January 27, 2015
BOARD OF COUNTY COMMISSIONERS
ORANGE COUNTY, FLORIDA
Addendum No. 3, IFB Y15-740-SB
ORANGE COUNTY PARKS AND RECREATION WAREHOUSE HVAC
REPLACEMENT

Bid Opening Date: February 3, 2015 at 2:00 P.M.

Key Plan
 MPE PROJ#: 2013-212A
 Designed By: MLM
 Drawn By: SB
 Checked By: MLM
 Issue Date: 12/01/14
 Drawing Scale: N.T.S.
 Drawing Title:
**REFLECTED CEILING PLANS
 DEMOLITION RCP / PROPOSED RCP**
BID/PERMIT DOCUMENTS
 Drawing No.
A-3.0.1

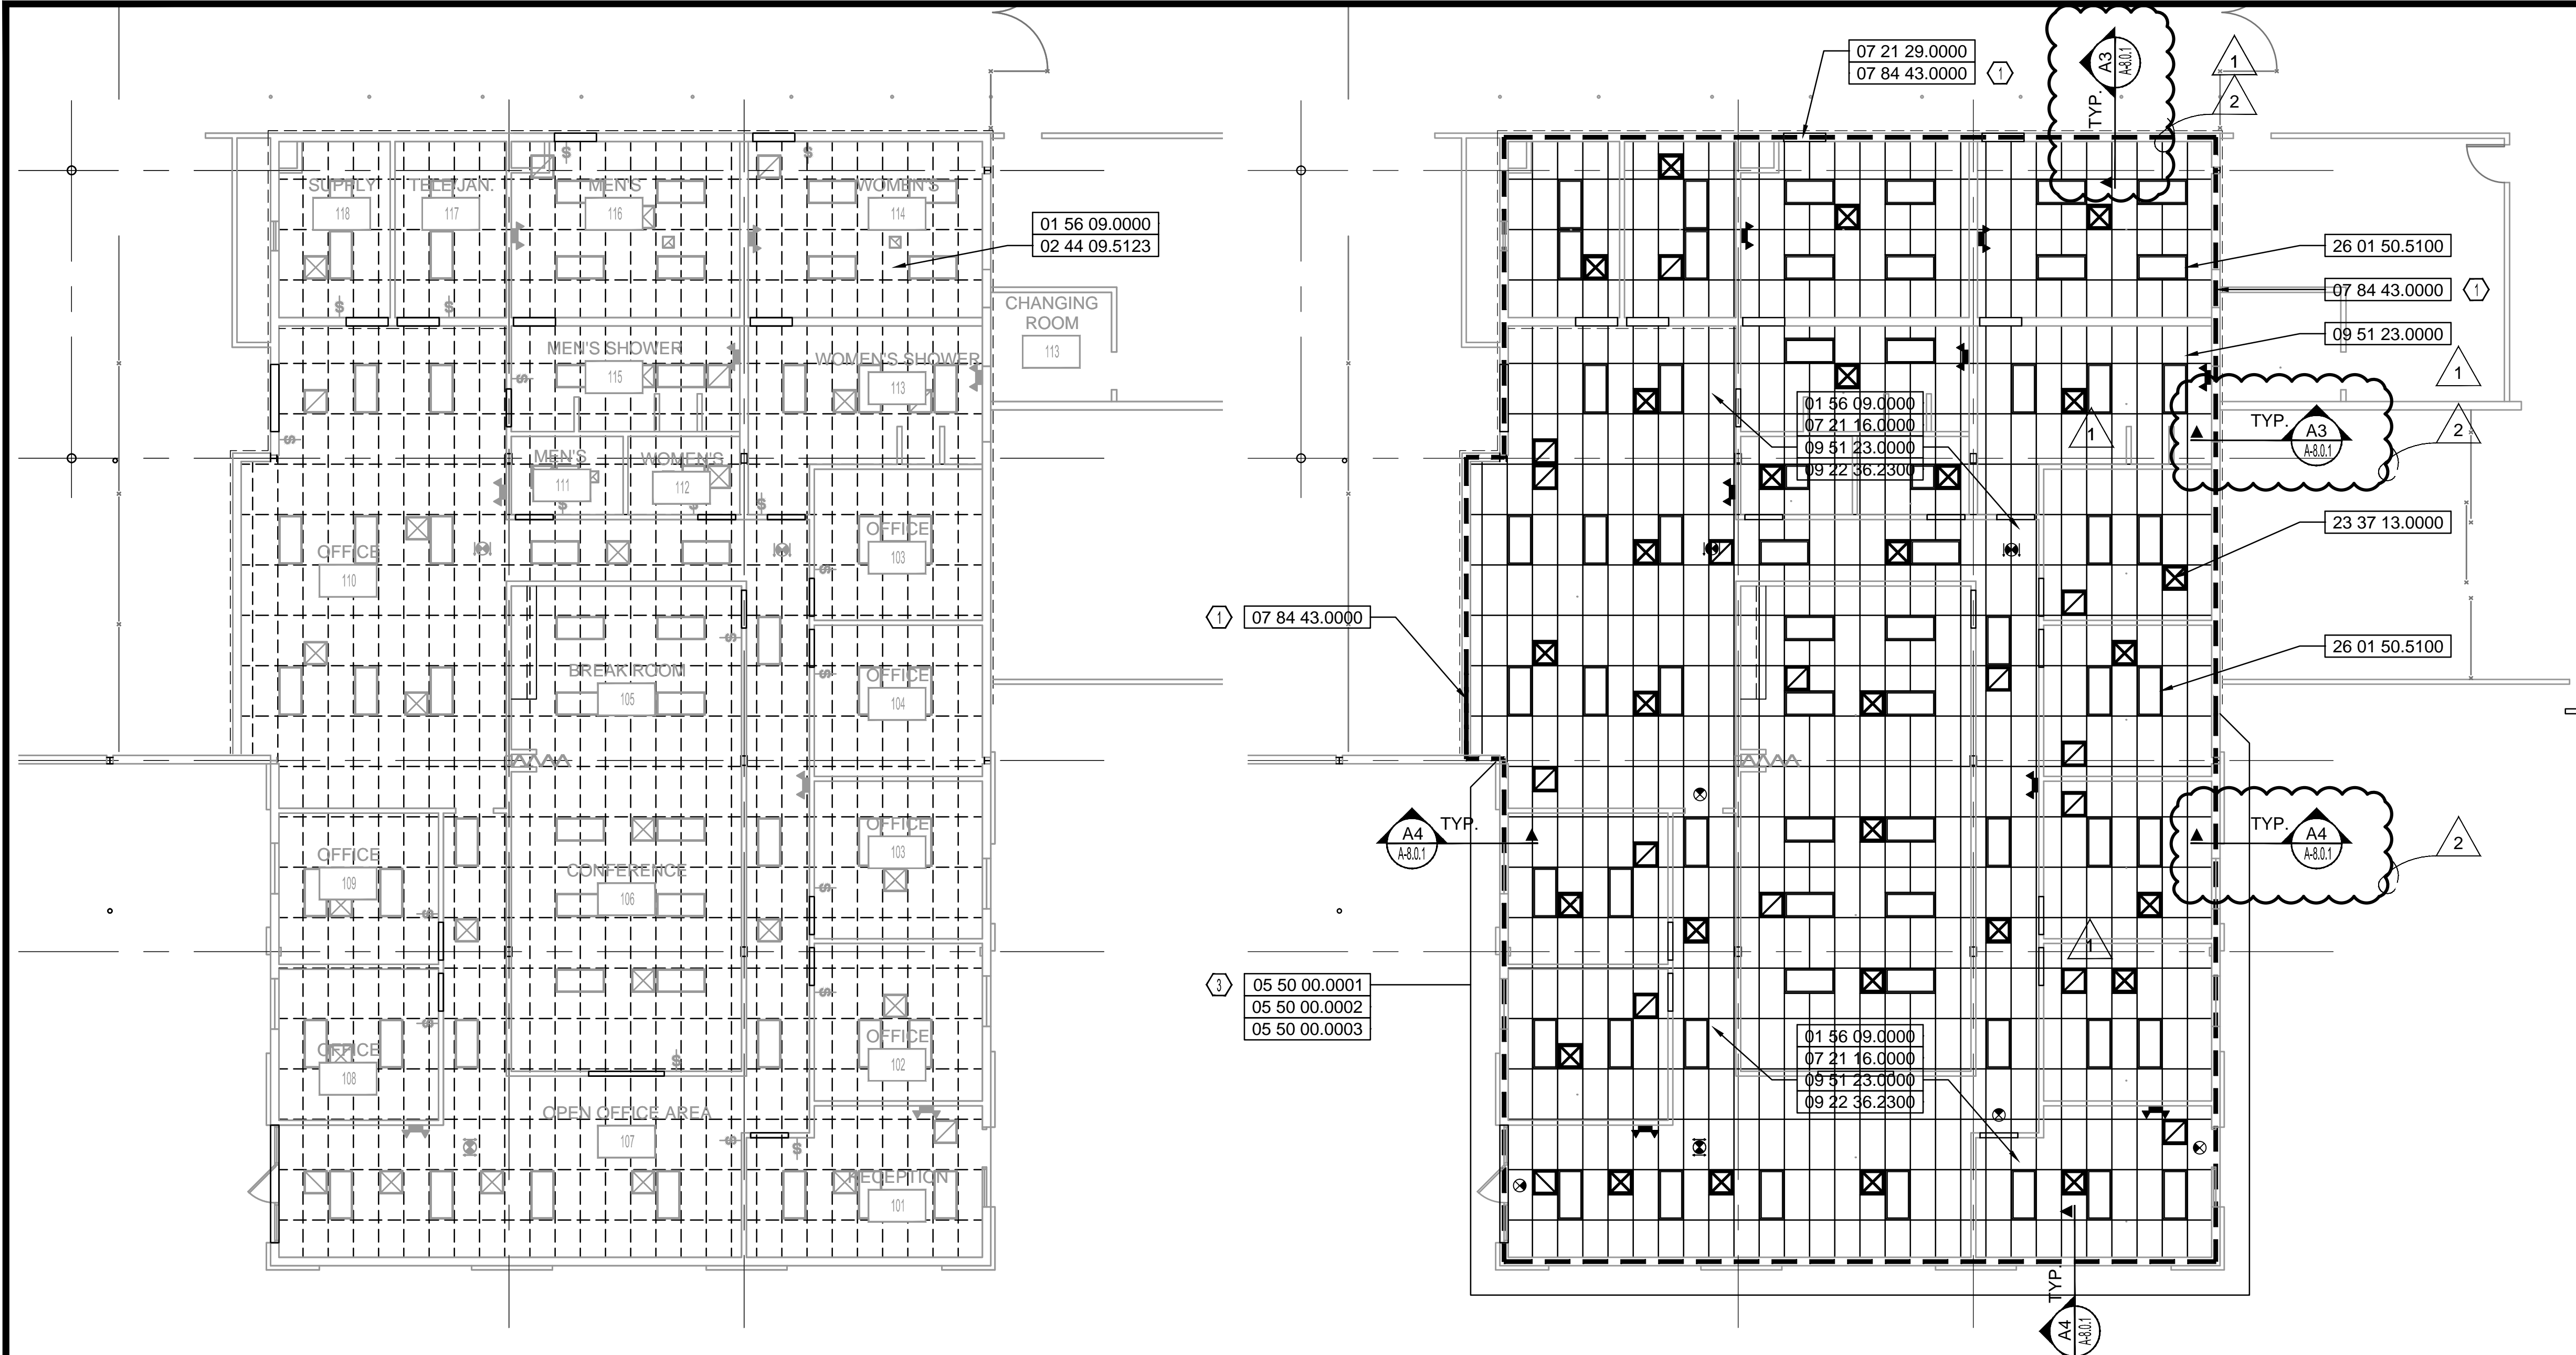
2. **Question:** During the site walkthrough which occurred on January 20, 2015, additional clarification was requested related to the wall construction reflected in Section A3/A8.01 and Section A4/A8.01 due to possible conflict with existing electrical boxes.

- **Sheet A-3.0.1** Dated 12-01-2014 with Revision 2 date of 1/26/2015:
ADD: New interior wall section identification marker depicting wall assembly on the interior of warehouse facility space.
REMOVE: Conflicting sheet note 09 01 50.9100 identifying existing ACT for patch and repair.
- **Sheet A-8.0.1** Dated 12-01-2014 with Revision 2 date of 1/26/2015:
ADD: Typical wall section on interior of warehouse facility space added for clarity.

Answer: Drawing Sheets A-3.0.1 & A-8.0.1 (attached) have been revised to address this. Summary of changes is noted below:
